Interactive comment on “A multi-purpose, multi-rotor drone system for long range and high-altitude volcanic gas plume measurements” by Bo Galle et al.

Bo Galle et al.

Received and published: 6 March 2021

Fig. 1. This is a new Fig.1. showing some flight log data

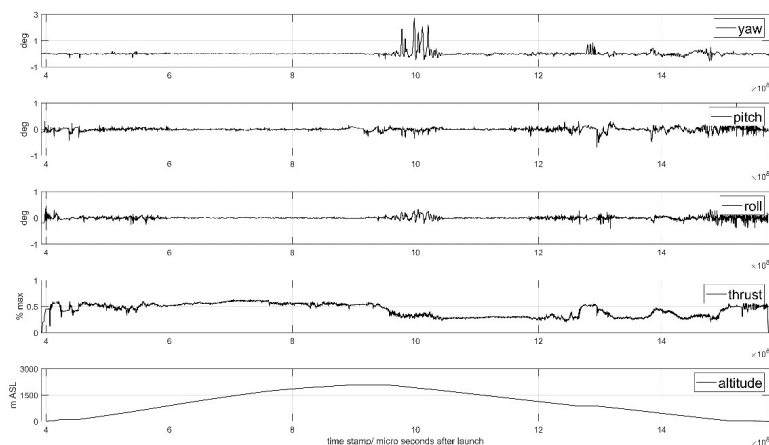
Reviewer: l.149-156: These seem like very important operational observations. However, critical details are left out or are too vague. “The drone’s angle...also proved to be of great important for energy consumption.” Can this be made more specific and

actionable? What is an optimal flight vector? Roughly how much endurance might the flight optimization gain? Why did power consumption go up so much when encountering clouds?

Reviewer: l. 169-171: “Access to the drone flight logs were found to be useful...” I agree that they would be very useful for the reasons stated. Please make the logs available as part of the data release.

Response: The energy consumption probably goes up in clouds due to increased turbulence, forcing the drone to react. More on this is given on the new page 7 and new Fig 1. , attached as Fig 2 here with new caption "Flight data from the drone flight shown in Figure 9. The upper panels show time-series of yaw, pitch and roll angles, the thrust (percentage) and the altitude of the drone. Notice the high variability of the parameters associated with acceleration, hovering and interference from clouds."

Response: We think it is a bit too much to include the full flight logs for all the flights in

the data release. We have however included some flight log data for a typical flight in the new Fig.1. (attached here as Fig. 1.)

Fig. 2. This is the new Fig.2., replacing the earlier Fig.1.

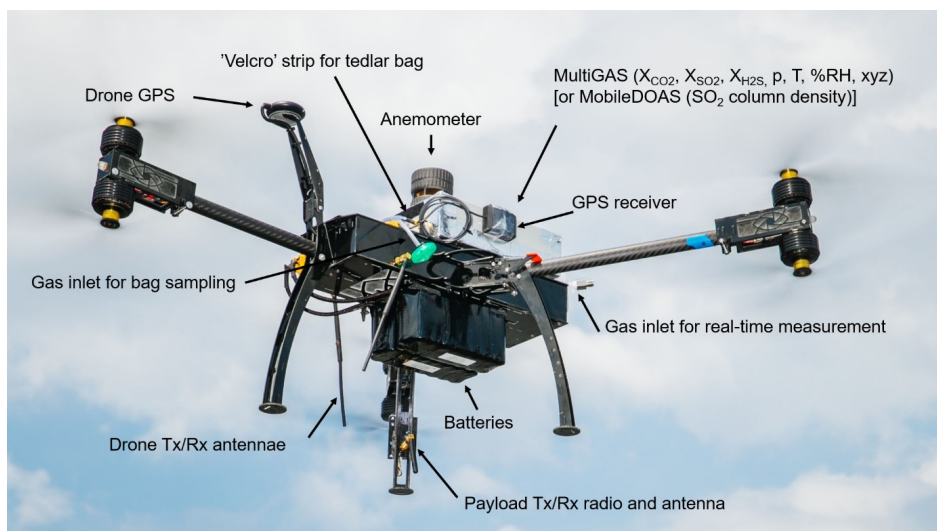
Reviewer: 2. Figure 1 of the manuscript is copied verbatim from Liu et al. (2020) supplement Figure S3b (shown below) and without correct attribution. Although the team for the two papers are much the same, ‘recycling’ figures in this way is poor practice and - at minimum - any previously published images and/or figures need to be cited properly.

Response: We have replaced the figure using a different background photograph and adding more details for the sensors and other instrumentation (New Figure 2, attached as Fig 2 here). Caption: "Photo of the multi-rotor drone with modular payloads. The MultiGAS unit includes in situ sensors for gas composition (XA-denotes concentration of species A, p-pressure, T, temperature, %RH-relative humidity, xyz-tilt coordinates), a gas-sampling unit and an anemometer. The MobileDOAS is used for remote sensing of gas flux. The modules are clamped to the drone at balanced position. The battery pack is placed below the drone chassis to lower the center of gravity of the system. Flight and sensor data are telemetered in real-time (photo courtesy of Matthew Wordell)".

Fig. 3. Figure illustrating closed loop gas-bag measurements, Fig S.1. in Supplement

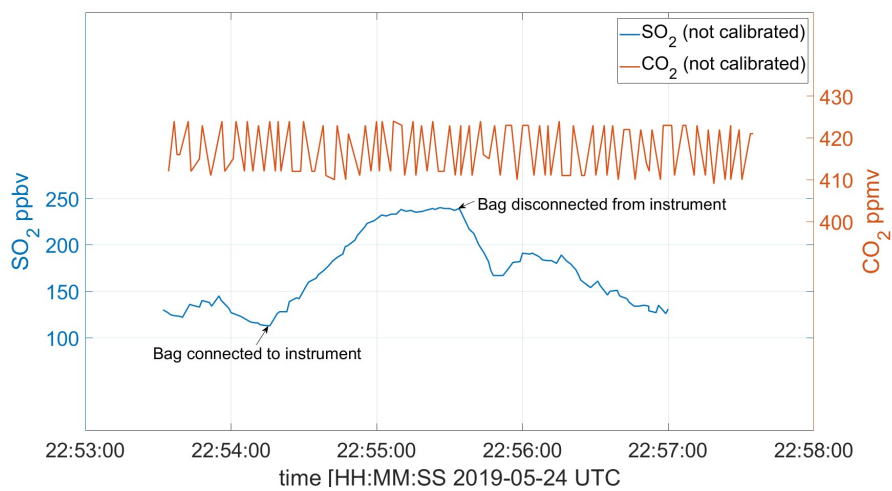
Reviewer: L.327-329: This is an interesting idea, but I do have concerns about its viability. Would a ~1L tedlar bag provide enough gas to get a good 'plateau value' from the sensors? How long do the sensors take to plateau during calibrations? Also, at low concentrations I would expect some sorption of S-containing species that could impact the results.

Response: We have added: “In this mode the gas from the teflon bag is circulated through the detectors in a closed loop and thereby exposing the detectors for the constant gas concentration in the sample for several minutes. Another advantage here is that any possible losses, i.e. wall effects, could be monitored and compensated for. This method was tested only once in the actual field campaign, because the limited gas samples was instead used for isotopic composition analyses.” The only test made to practice the method used a sample that was too diluted for a successful measurement of CO₂, but it probed that the closed-loop principle could work. The figure of the uncalibrated signals for this test is shown as Fig.3. here (measurement on 22 May 2019). As clearly shown, the SO₂ signal is detectable and its curve of growth stabilized in about 30 s (t₉₀), which matches well with the manufacturer's specifications. But the signal, after calibration, is less than 1 ppm and therefore the CO₂ signal above background is below the detection limit of the instrument (remember the molar ratio for both species at Manam was found to be close to 1). The figure also shows a noise picked up by the CO₂ sensor, which we attribute to the radio. This signal is subtracted together with the background as part of the corrections. This information is included in the Supplement.
